Groundwater Application Review Summary Form

Application # G- 19460

PUBLIC INTEREST REVIEW FOR GROUNDWATER APPLICATIONS

A. GENERAL INFORMATION: Applicant's Name: Clearlake Farms, LLC County: Marion

Theis Interference Analysis-POA 1/Johnson Well (MARI 17388)

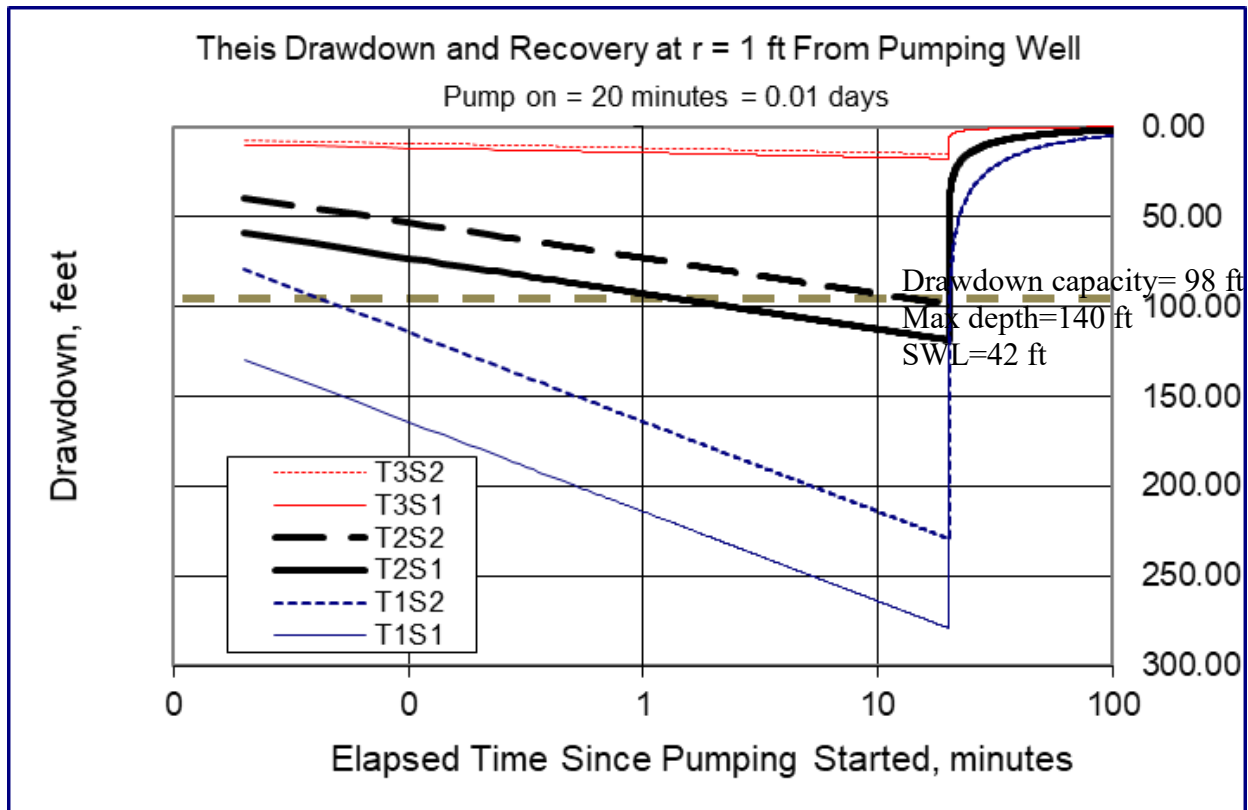
A Theis drawdown analysis on the total drawdown within the pumping well was completed for each of the respective proposed maximum combined rates and compared to the anticipated drawdown capacity for each well. The drawdown capacity was calculated as the most recent static water level minus the maximum depth of the well. Results indicate that the proposed rates are likely to completely dewater the existing POA wells within 30 minutes. Therefore, the proposed use is not in the capacity of the resource.

Based on this analysis of the available data and under the assumptions previously identified, groundwater for the proposed use is likely not within the capacity of the resource; if a permit is issued for this application, the conditions in B1(d)(i) and B2(c) are recommended to protect senior users and the groundwater resource.

Theis Interference Analysis-POA 3/Proposed New Well (PROP 600) and MARI 71298

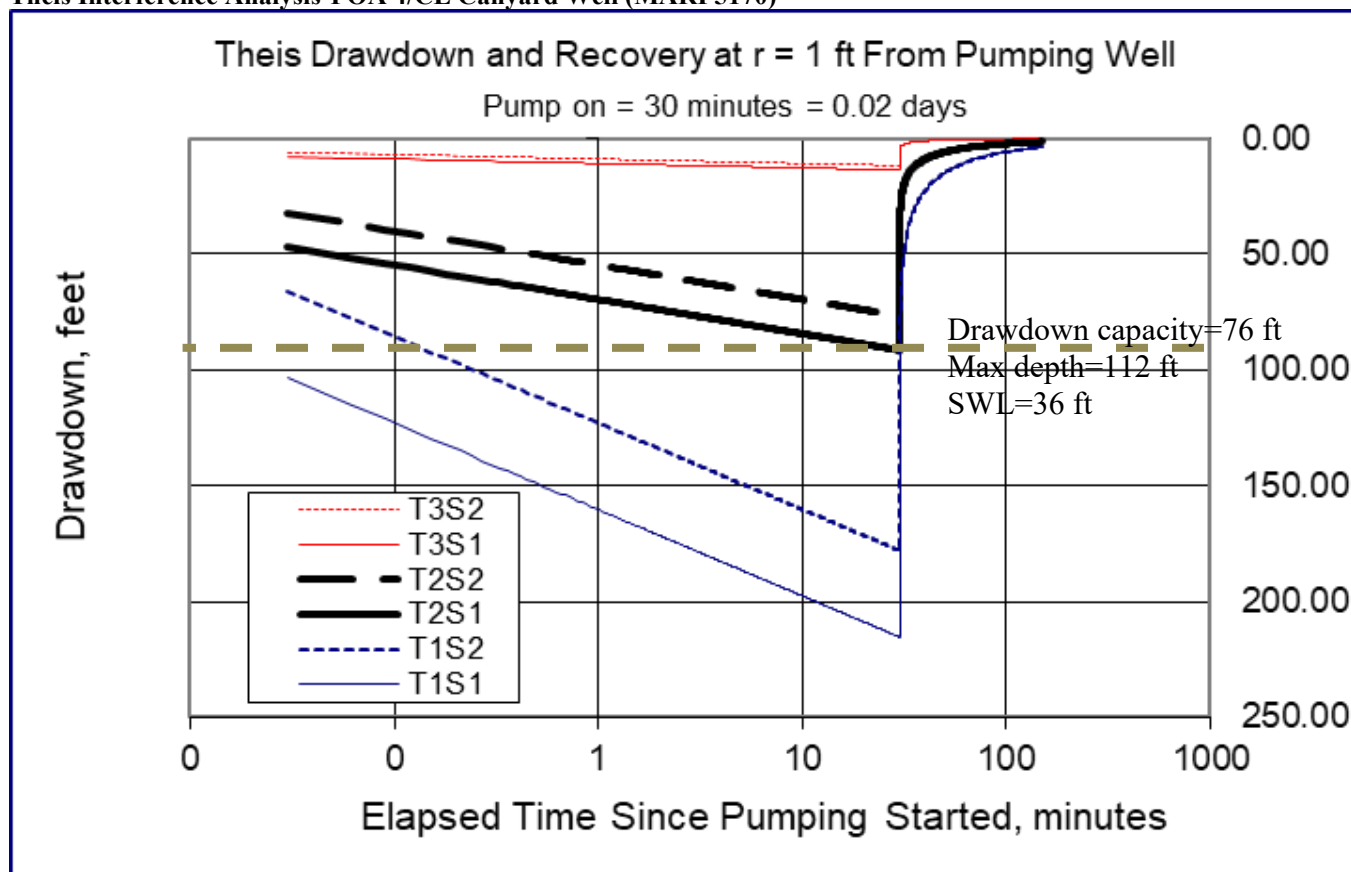
The nearest groundwater user to POA 3/Proposed New Well (PROP 600) is MARI 71298 (an exempt domestic well) located 972 ft southwest and at an elevation of 184 ft amsl. To assess the degree of drawdown, a Theis drawdown analysis was conducted for the proposed use (see attached Theis Drawdown Analysis). **Results indicate that the proposed use is likely to cause well-to-well interference with MARI 71298 that exceeds the threshold under the standard condition for alluvial aquifers in the Willamette Basin within 8 days. Therefore, the proposed use is not in the capacity of the resource.**
